**NSW Planning Assessment Commission Determination Report
Old Clare Hotel, Block 3A, Central Park MP 11_0089 MOD 3**

On 16 October 2017, the Planning Assessment Commission (the Commission) received from the Department of Planning and Environment (the Department) a request to modify the Project Approval (MP 11_0089) for the redevelopment of the Old Clare Hotel at Block 3A, Central Park, in the City of Sydney local government area. The request was lodged by Cirillo Planning Trust (the proponent) and seeks to expand the use of a rooftop bar, establish restrictions on its use, construct a single storey roof structure and a single storey extension containing three toilets on the existing rooftop terrace.

Figure 1: Long Section/East Elevation

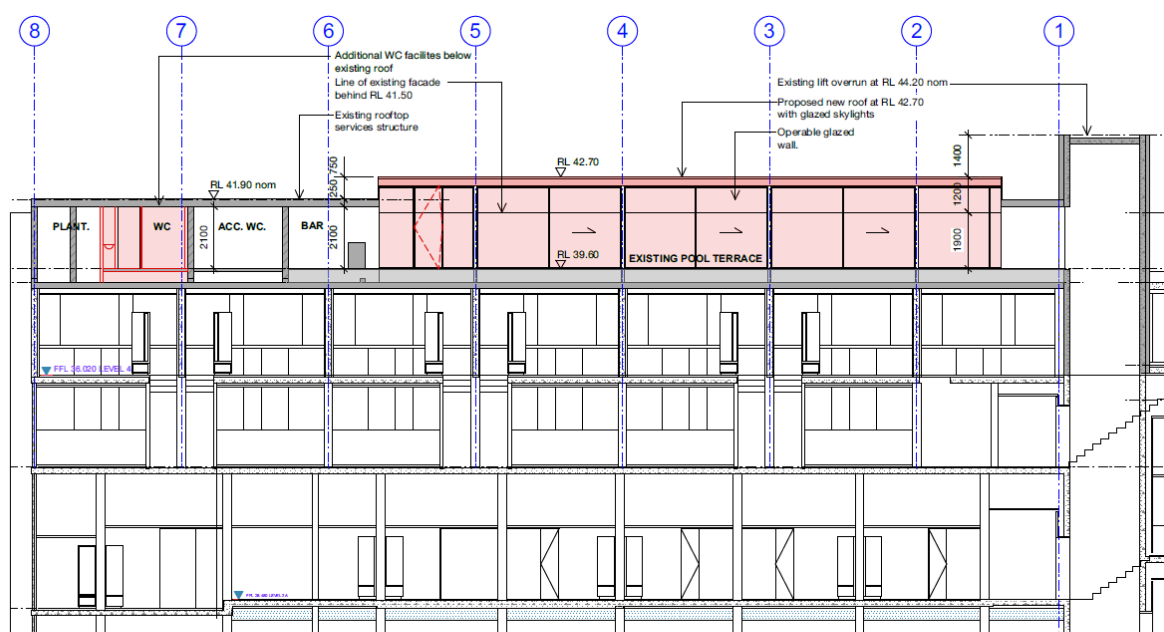
During the site visit, the proponent outlined how the proposed rooftop structure would be constructed along the western edge of the building façade and explained that the structure would be fully enclosed but would contain sliding doors, as shown in the Plans for Approval (see Figure 1). The proponent volunteered that it would be willing to ensure, by way of condition, that between the hours of 8pm and 10pm, the doors could be closed to avoid potential noise impacts on residents of One Central Park. The Commission sought clarification from the Department, confirming that while the doors are shown on the plans for approval, the Acoustic Assessment states: *'It is necessary to consider the detailing of the junctions to ensure all gaps are sealed airtight so that the acoustic performance of the rooftop canopy is not compromised through sound flanking or leaking through the construction'*.

The Commission considers that the requirement for a noise audit within 3 months of operation will allow issues to be identified and enable any occurring impacts to be rectified. The Commission does not support the opening of the sliding doors and has therefore recommended Condition B23(c) to require the western elevation be constructed with no openings.

On 22 November 2017, the proponent submitted an updated Acoustic Assessment, which included modelling of the sliding door scenario. The proponent acknowledged that while the western elevation sliding doors had always been part of the design, neither the Acoustic Assessment of the Department's assessment had considered the management of the doors in their assessments. The updated Acoustic Assessment concluded that the sliding doors would need to be closed when the venue exceeds 30 patrons (50% actively speaking at once) and when music is playing through loudspeakers. The proponent recommended a condition requiring:

- management procedures be established to ensure that when occupancy increases above 30 patrons, or music is played the western elevation doors would be closed; and
- construction of the sliding door must be undertaken to achieve a nominal sound insulation performance to suitably limit sound transmission through the enclosure.

The Commission sought advice from the Department regarding the proponent's updated Acoustic Assessment and suggested condition. The Department confirmed that it did not support the proposed change to allow the sliding doors to be open, as it did not form part of the application as originally notified and had not been assessed by the Department. The Department advised that its assessment was based on the western elevation being shut and sealed at all times, as was the proponent's Acoustic Assessment (22 September 2016)

Based on the recommendations in the Acoustic Assessment, the Commission finds that in order to effectively manage noise impacts, while the rooftop terrace pool and bar is in operation, the sliding doors would need to remain closed. Retaining the doors in a closed position, would prevent noise impacting on neighbouring residents, which is consistent with the assessment submitted by the proponent in its original application and assessed by the Department. The Commission finds the proposal to require the sliding doors be closed when the venue exceeds 30 patrons, has a number of shortcomings including the fact that it would be difficult to manage from a compliance perspective. Condition B23 stipulates the requirements for the rooftop structure, including that it be amended in accordance with the recommendations of the Acoustic Assessment prepared by Parsons Brinckerhoff, dated 22 September 2016.

DRAWING
PRIVACY FILM STUDY

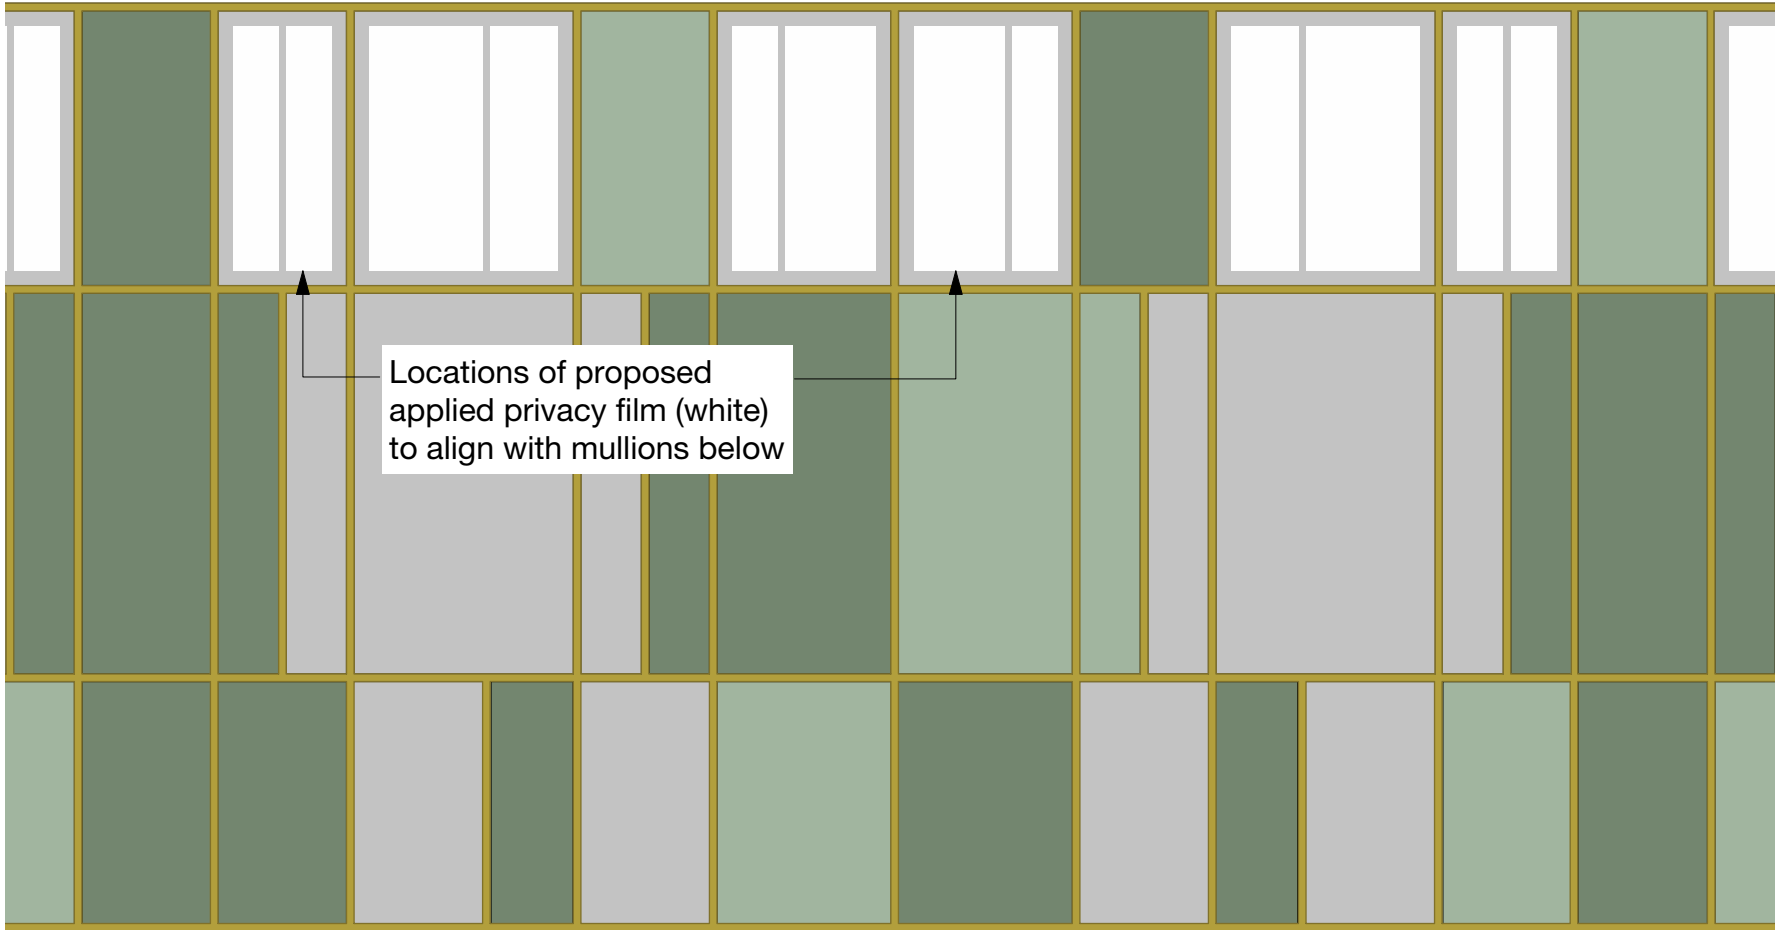
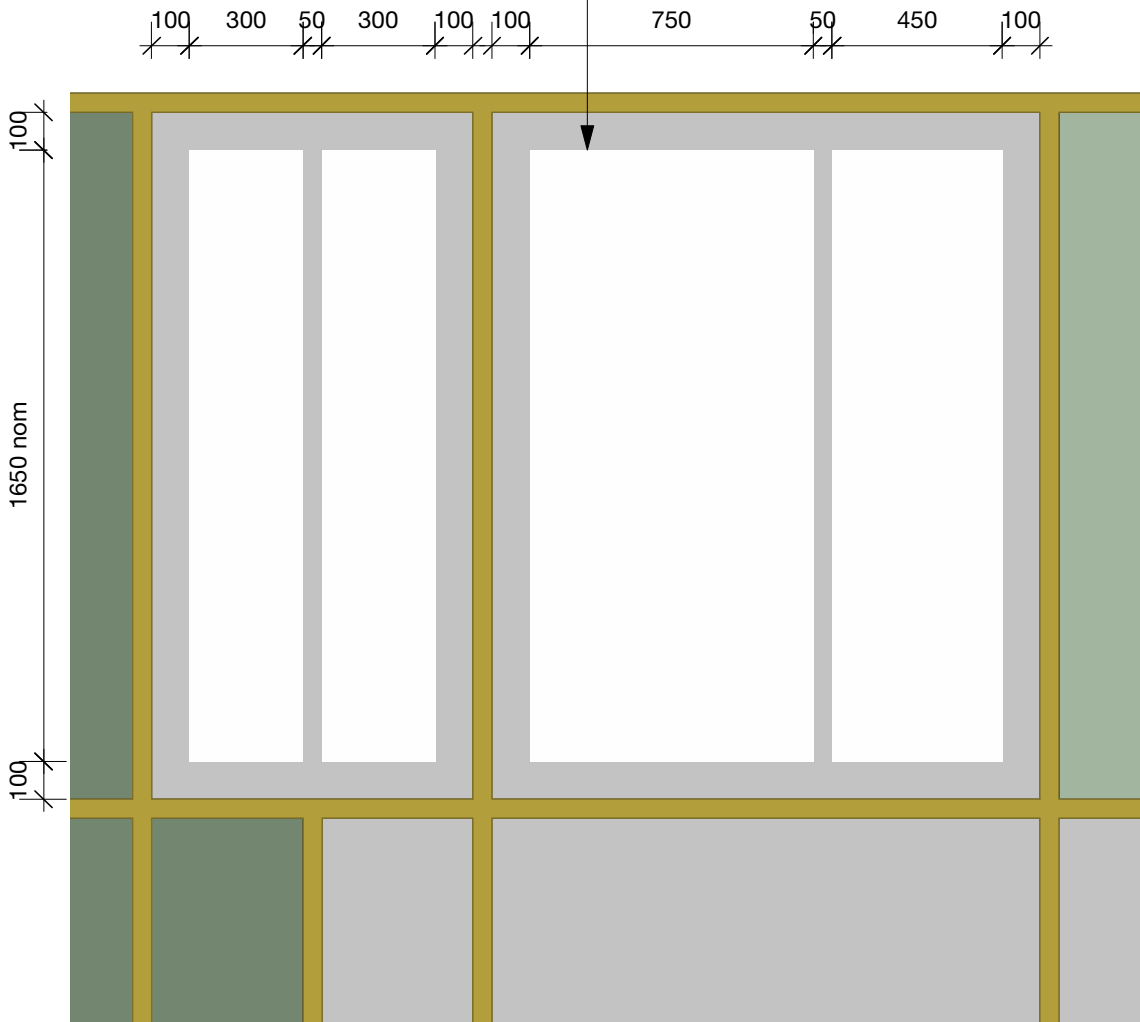
The Department, subsequent to the recommended design and conditional changes, found that the amendments identified by the proponent would sufficiently address privacy concerns. To prevent overlooking, the Department recommended a condition requiring obscured glazing be installed along the western elevation of the roof structure. During the site visit, the proponent presented an alternative treatment for the western façade to address privacy concerns. The treatment involves applying translucent privacy film to the western glazed elevation, in order to obscure views from the rooftop in accordance with the Privacy Film Study (Drawing SK04).

The proponent wrote to the Commission on 20 November 2017 formally submitting the alternative treatment privacy treatment for the Commission's consideration. The proponent also requested various amendments to Condition B23. The Commission sought advice from the Department and determined to retain both the requirement for the roof structure to increase transparency on the western side of the roof by 40% and the requirement for a gloss finish to the soffit cladding, as these measures were proposed by the proponent to address concerns raised by Council. The Commission supports the proposed translucent privacy film on the western façade as it will provide additional privacy to residents of One Central Park. The conditions have been amended accordingly and the plan showing the privacy film study included in the table of plans (Condition A2). The updated plan is provided in Appendix 4.

The Commission finds that the proponent's proposed translucent privacy screen on the western façade will provide additional privacy to residents of One Central Park. The conditions have been updated to reflect this amendment. Further, the Commission considers that any visual and urban design impacts would be very minimal and have been addressed as far as practicable through the proponent's amendments.
